**From:** Hayes, Eliana  
**Sent:** Monday, August 12, 2024 12:20 PM  
**To:** Kurt A. Jones  
**Cc:** Gue, David; Tessier, Meredith  
**Subject:** RE: 30-DR-2021#5 Trash Pickup Clarification  
**Attachments:** D220690\_A1.7 - SITE - TRASH PLAN-A1.7A.pdf; D220690\_A1.7 - SITE - TRASH PLAN-A1.7.pdf

**ATAVIA - ONE SCOTTSDALE**  
NORTH SCOTTSDALE, AZ # 2022-0690

DRB SUBMITTAL 3  
AUGUST 8, 2024

SITE PLAN - TRASH PICKUP PLAN

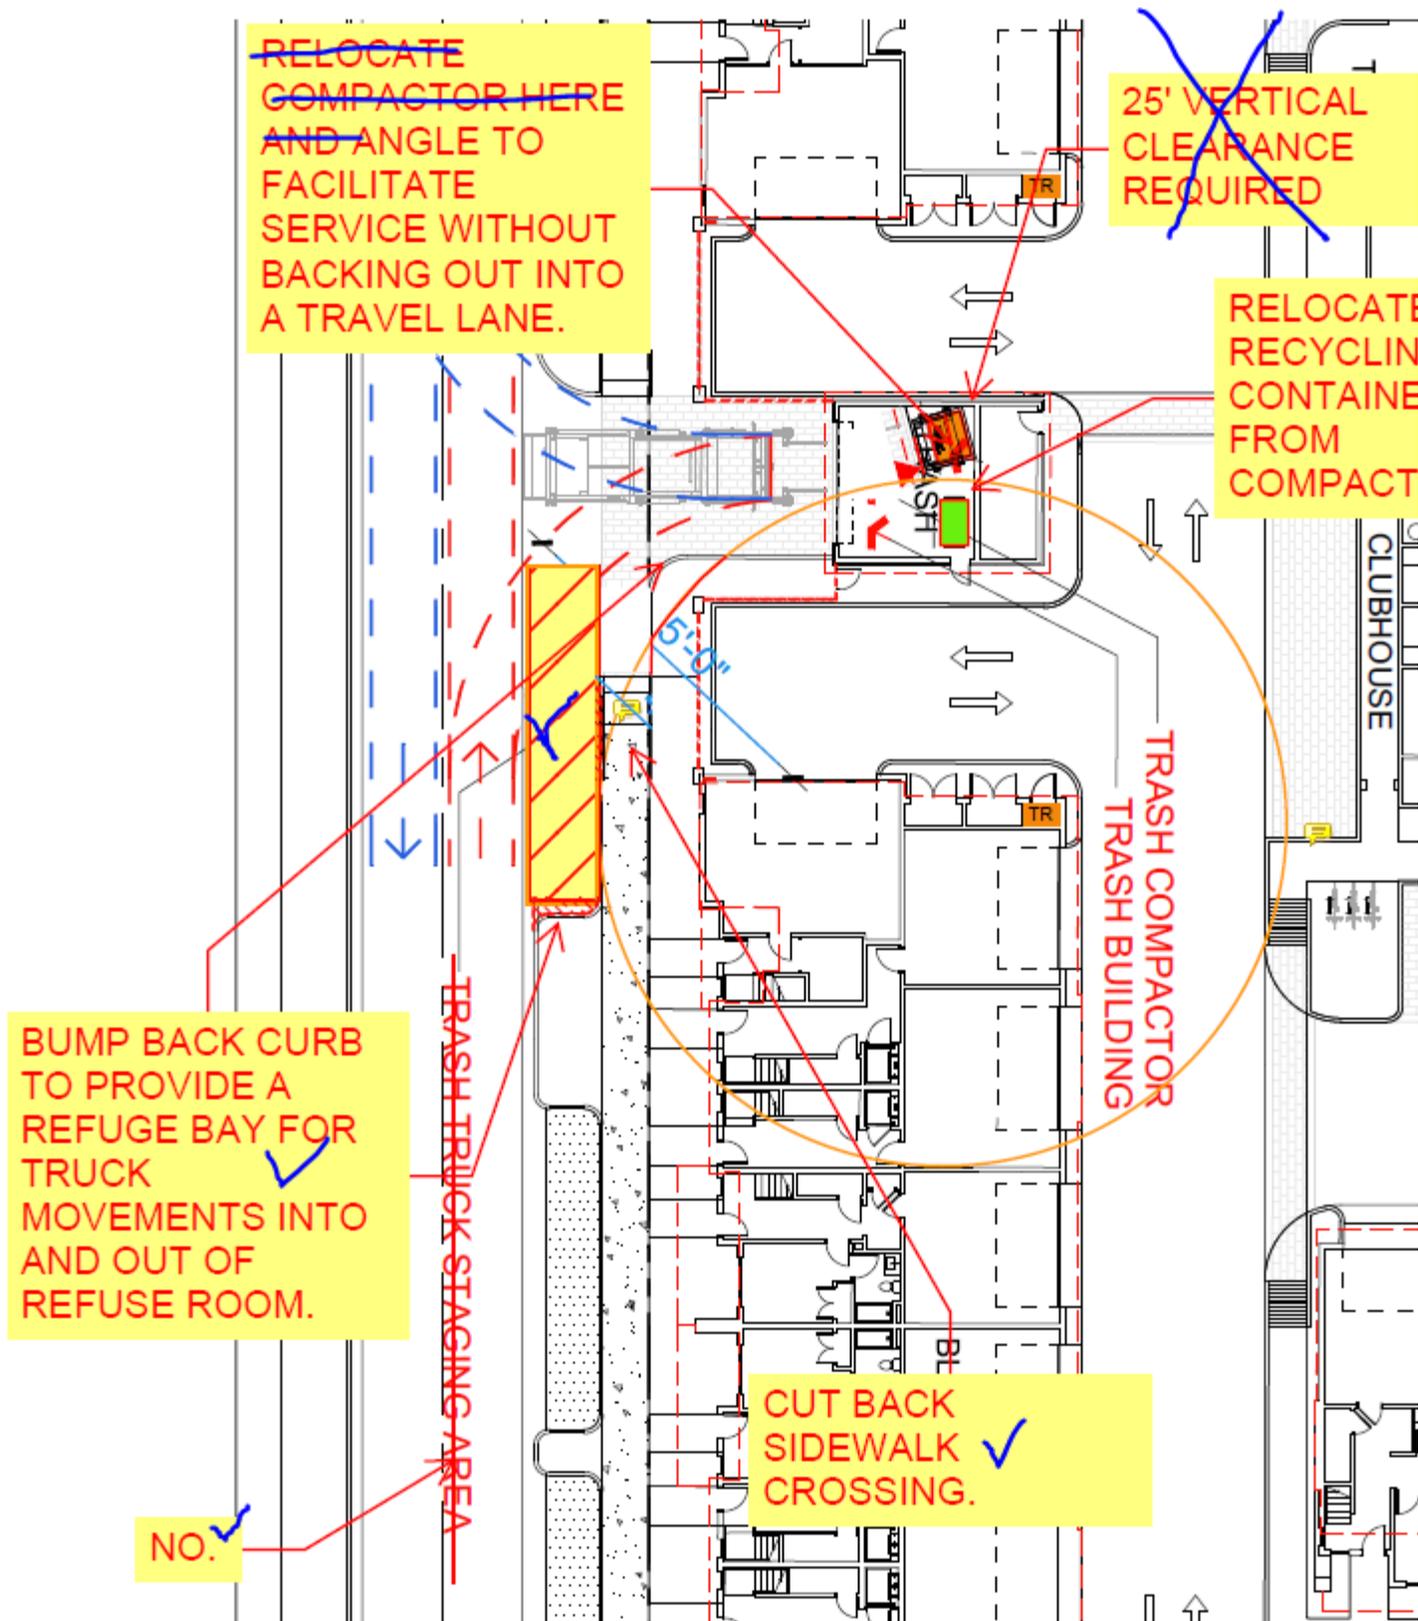
OK, and just to be clear, we don't need the 25 foot vertical clearance in the trash building either...correct? See below cross-outs and 'X' and then I check-marked in blue pen the changes you requested that we'll do...please verify and we'll get on it...thanks!

Do everything on my correction file except moving the container further into the refuse room.

We know it is front loaded and our comments are in response to it. The below does not address the correction file provided. An acceptable compromise may be to leave it at door but angle it, bump out the refuge lane, and curb lines per my correction file.

You will need a 14.5' vertical clearance at the door, but otherwise you are correct below.

A1.7A

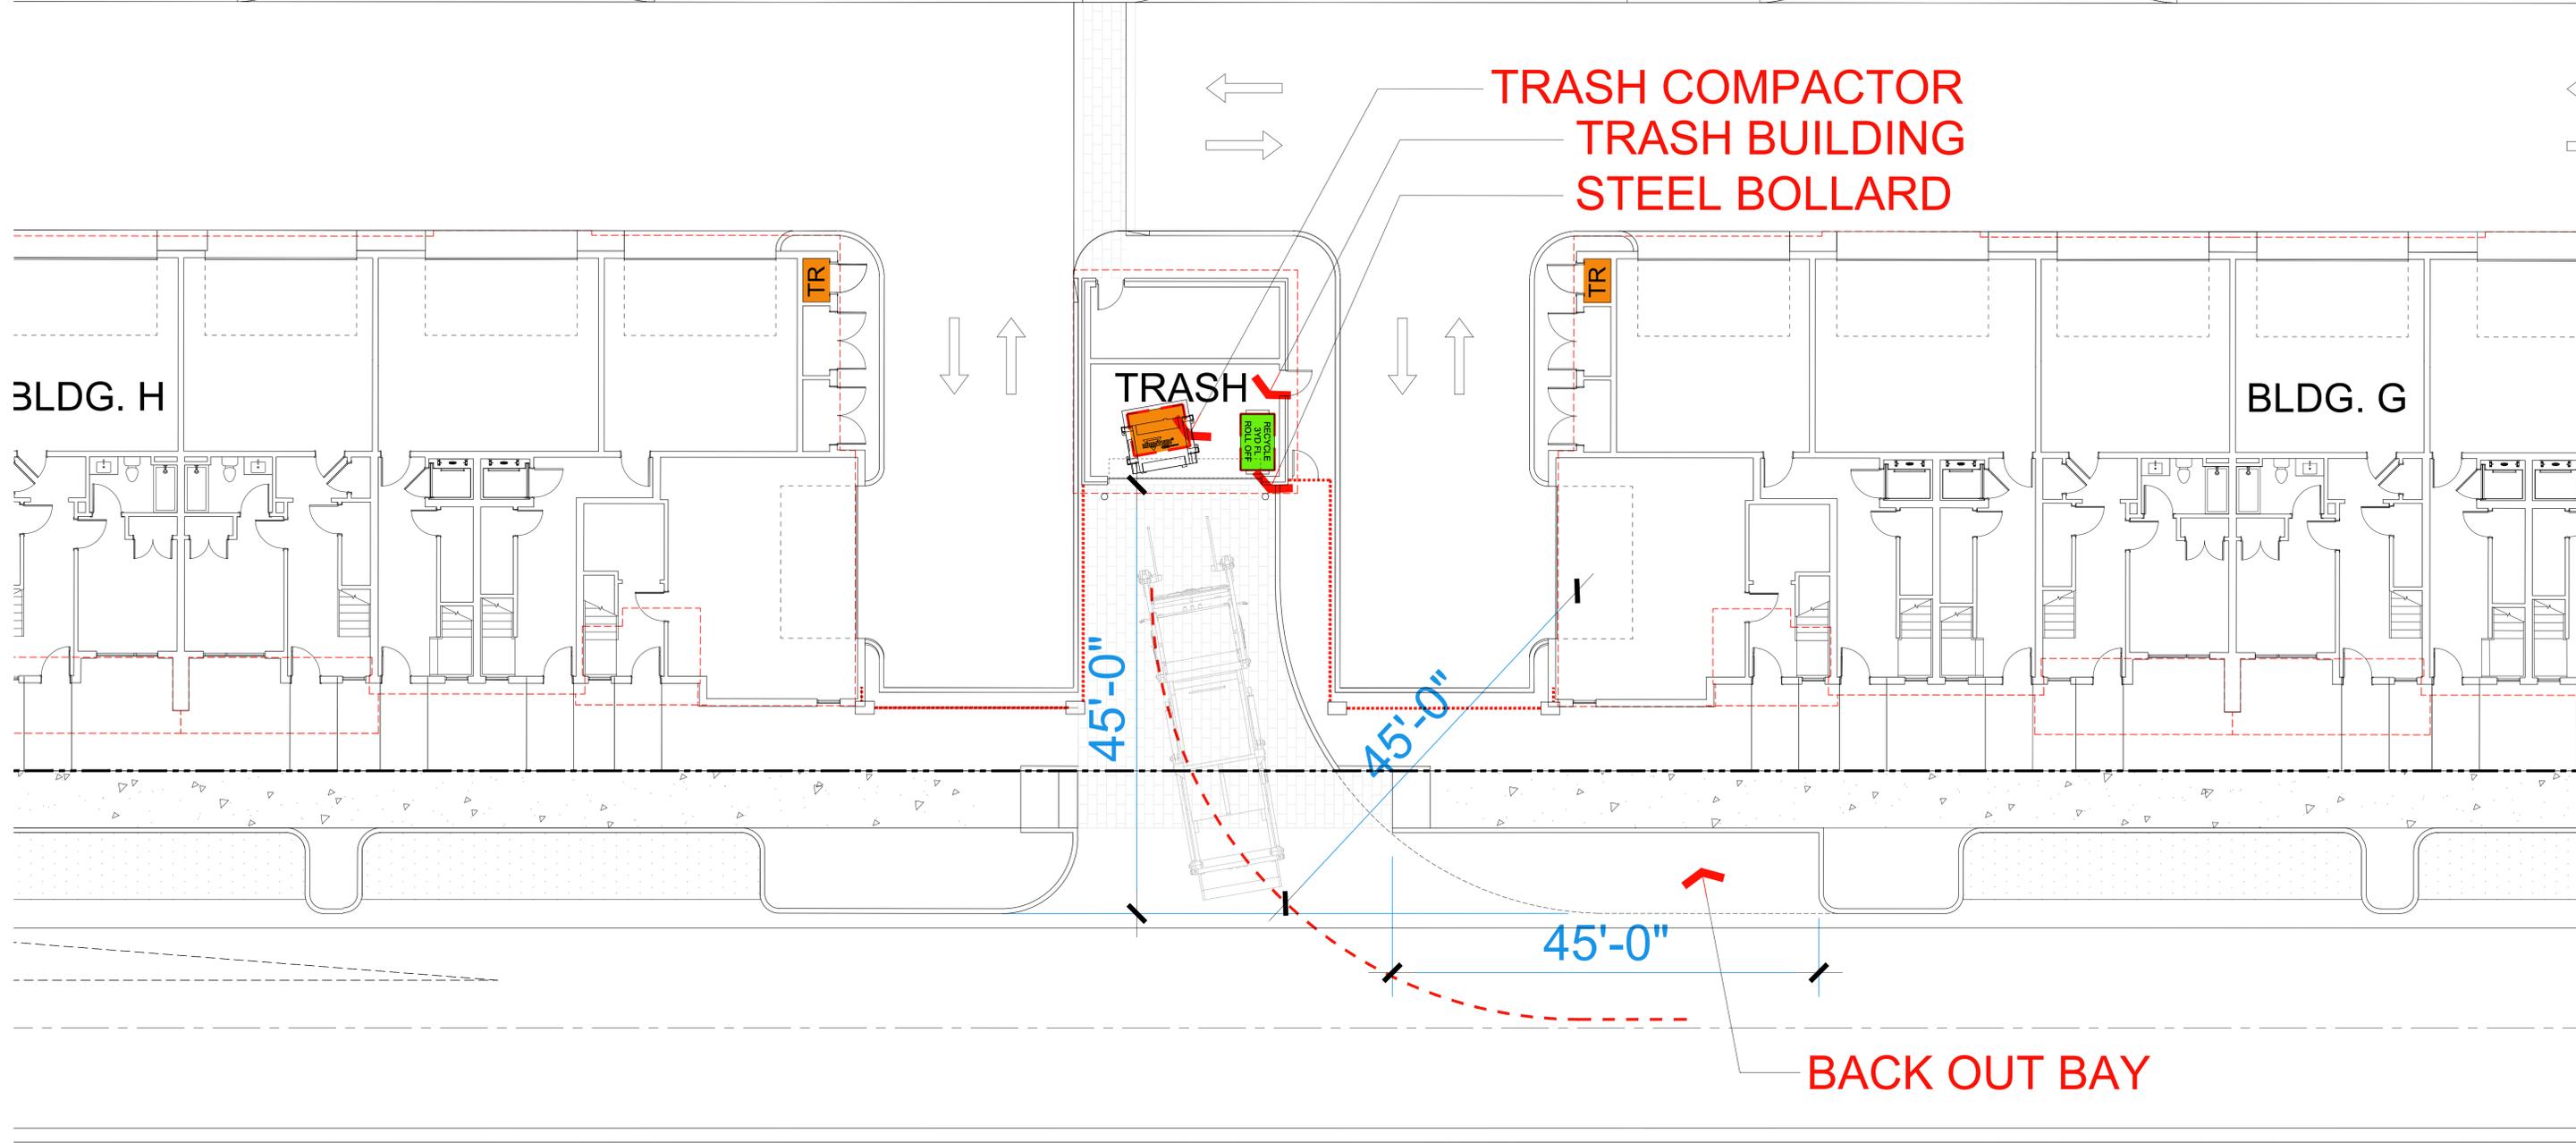
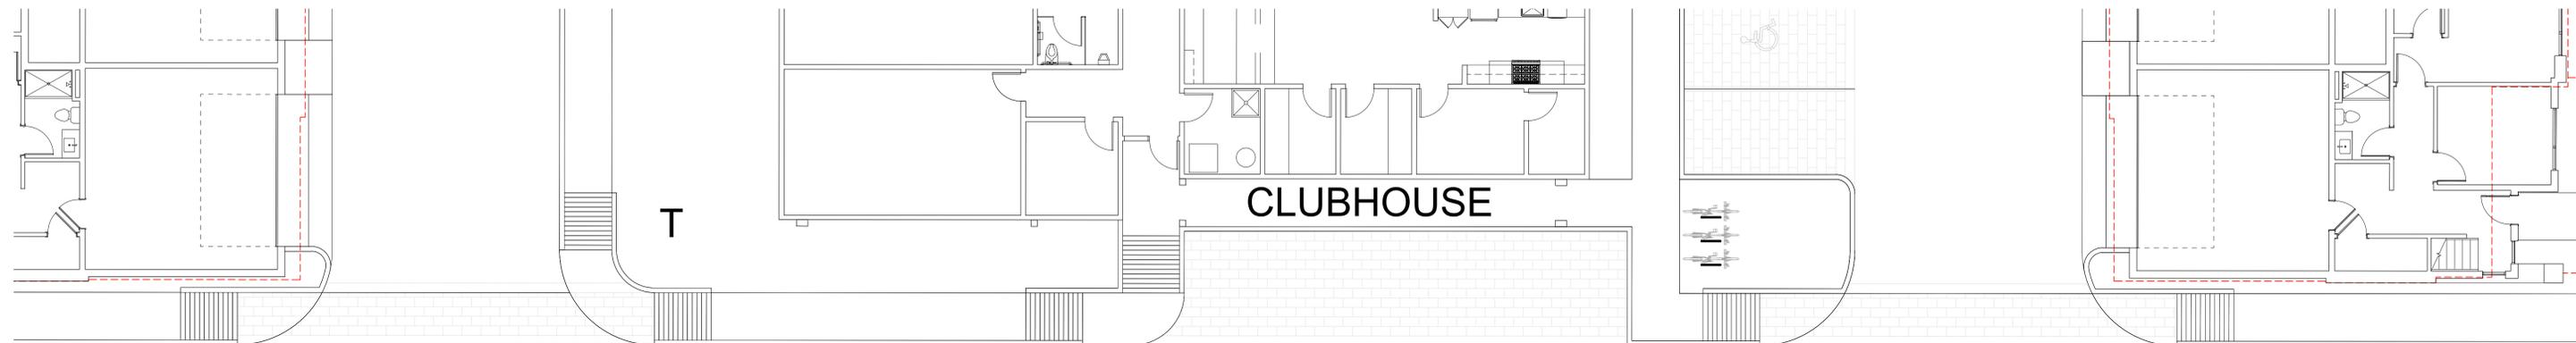
Please provide the requested 45' back out bay:

- Trash pickup intended to be from North or South direction. Compactor placement best served centered on overhead door to accommodate.

- Trash vehicle /Compactor unit is a “front “ loaded (pickup) trash compactor not “rear” loaded unit.
- Compactor Bin is approached by front forks of trash truck and requires much less depth than a “rear load” compactor.
- Trash truck pulls to the trash enclosure and only the front forks of the truck enter the building. The truck pulls the trash bin outside of the building and then lifts the bin overhead to unload. The bin is then pushed back inside the building. The trash vehicle DOES NOT enter the building at any time and overhead clearance is not an issue because it is outside the building at all times.
- Bollards shall be provided in front of the overhead door to stop the truck from damaging the building.

Per item (v) a 40'-0" truck (including the trash bin) is to be accommodated. KTGy recommends reducing Trash Building length by 5'-0" thus providing 45'-0" of clear area with no overhead obstruction for trash bin pickup. This allows for some maneuvering within the 45 ft loading zone without entering the fire lane area within the street. Please see original layout and revised layout attached.

As requested, attached please find revision inclusive of the 45'-0" back out bay.
